SUBJECT: 15825 Shady Grove Road – Shady Grove Innovation District – Development
Stormwater Management Concept Approval; SMC2024-00010, STP2024-00492

The Development Stormwater Management (SWM) Concept (Concept) received on May 28, 2024, for the above referenced site is conditionally approved. Staff has determined that the Development SWM Concept, as described below, achieves the required level of on-site Environmental Site Design (ESD) to the Maximum Extent Practicable (MEP), $P_E = 1.05$ -inch, equivalent to 58 percent of the required ESD volume (ESD_V), which exceeds the level of ESD as established by the Pre-Application SWM Concept letter dated January 4, 2019.

DEVELOPMENT STORMWATER
MANAGEMENT
PLAN

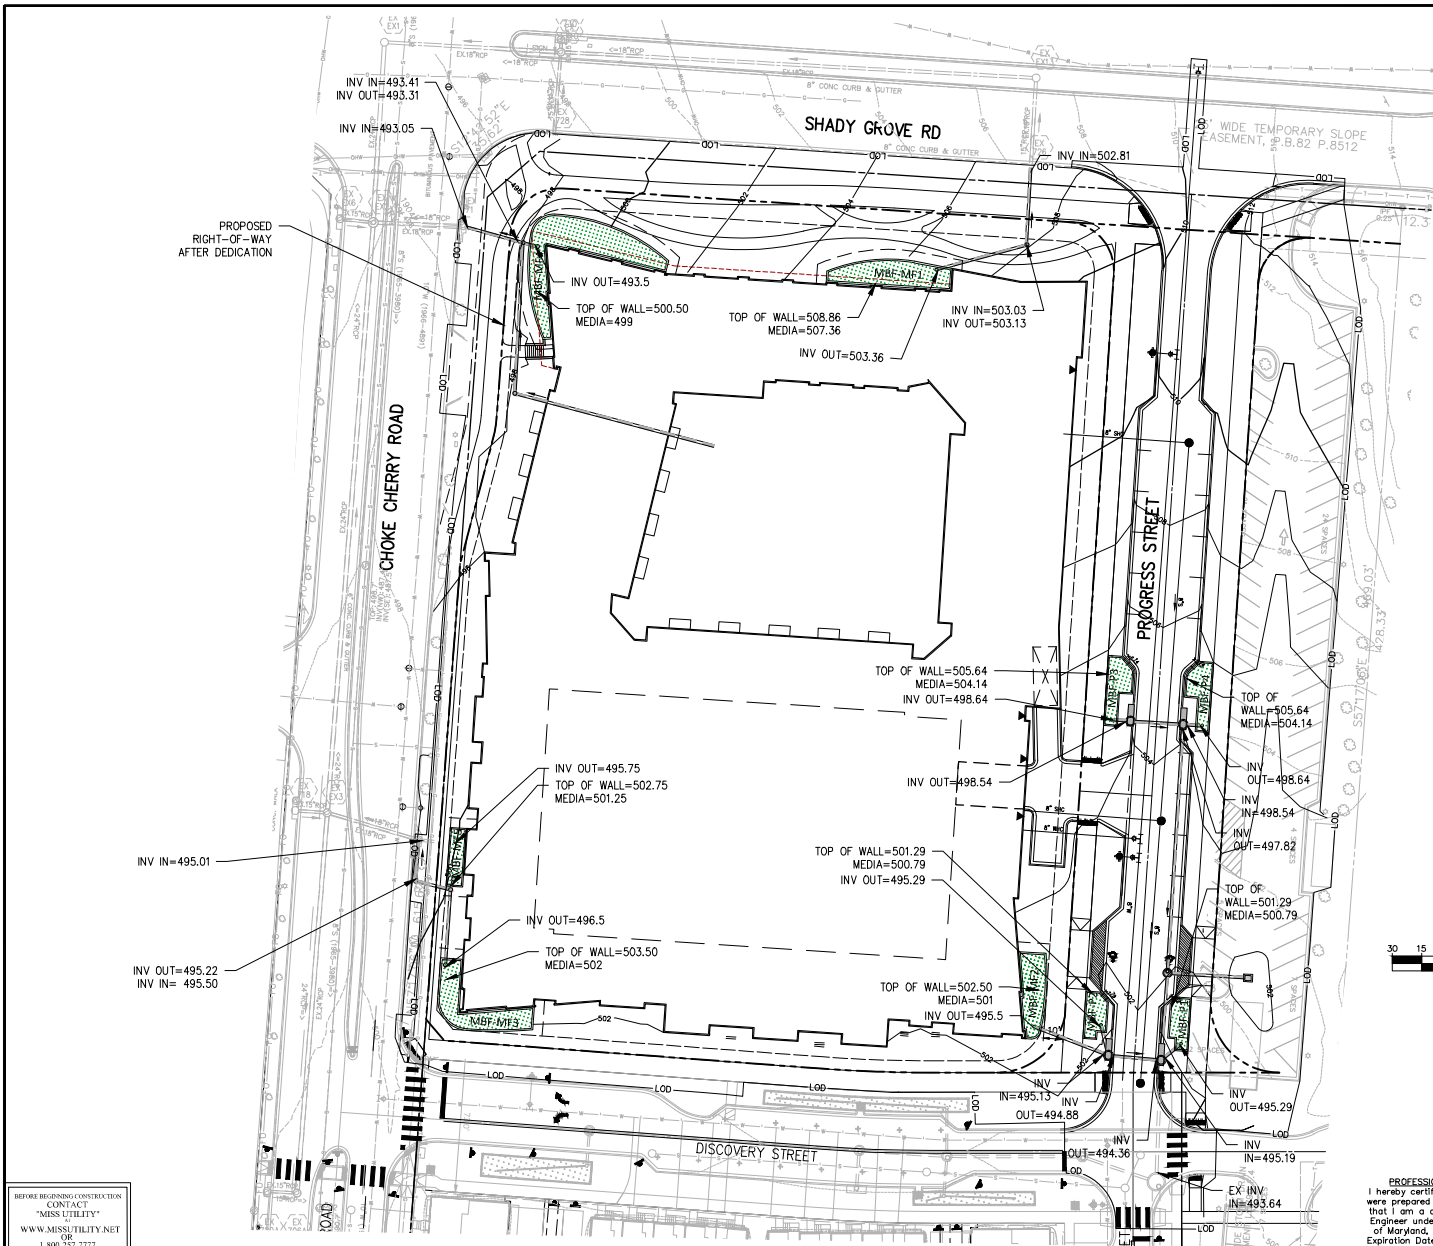
- The Concept proposes to provide a minimum $P_E = 1.05$ -inch equivalent to 58 percent of the required ESD_V in the following on-site measures:
 - 11 Micro-bioretention Facilities.
- Summary of ESD:
 - Total ESD_V provided = 12,122 cubic feet (cf.).
 - Total ESD_V required = 20,766 cf.
 - Percentage of ESD_V provided = 12,122 cf. / 20,766 cf. = 58 percent.

- Alternative Measures – Monetary contribution in-lieu of providing full ESD and in-lieu of providing Q_{p10} for the 3.15 acres of on-site impervious area.

- Alternative Measures – Monetary contribution in-lieu of providing WQ_V , Cp_V , and Q_{p10} for the 0.63 acres of impervious area in the adjacent ROW of Shady Grove Road and Gaither Road.

- 2) The submitted material must:
 - a) Demonstrate compliance with this Concept including locations, types, and sizing of ESD measures.
 - b) Include computations and construction details for review and approval by DPW:

- i) Design shall be in conformance with the latest version of the Montgomery County Department of Permitting Services Design Specifications for 11 micro-bioretenion facilities. Deviations from the specification must be approved by DPW.

- ii) Computations and plans must show the ESD_v water surface elevation.
 - iii) Utilize flow splitters, curb cuts, flow through inlets, or other methods approved by DPW to direct.

- iv) Overflow structures, underdrains, and tee configurations within the micro-bioretenion facilities must be shown on the SWM construction plans and approved by DPW.

- v) Where proximity of the micro-bioretenion facilities to the building and parking garage is less than 10-feet, a licensed professional engineer in the State of Maryland must determine if any special treatment, including impermeable liners, is required. Evidence of such investigation and recommendation must be provided with the final engineering.

- c) Identify paths for safe overland flow of the 100-year storm event with flow arrows.
 - d) Demonstrate that all components of the SWM system drain by gravity. Pumping of stormwater will not be permitted.
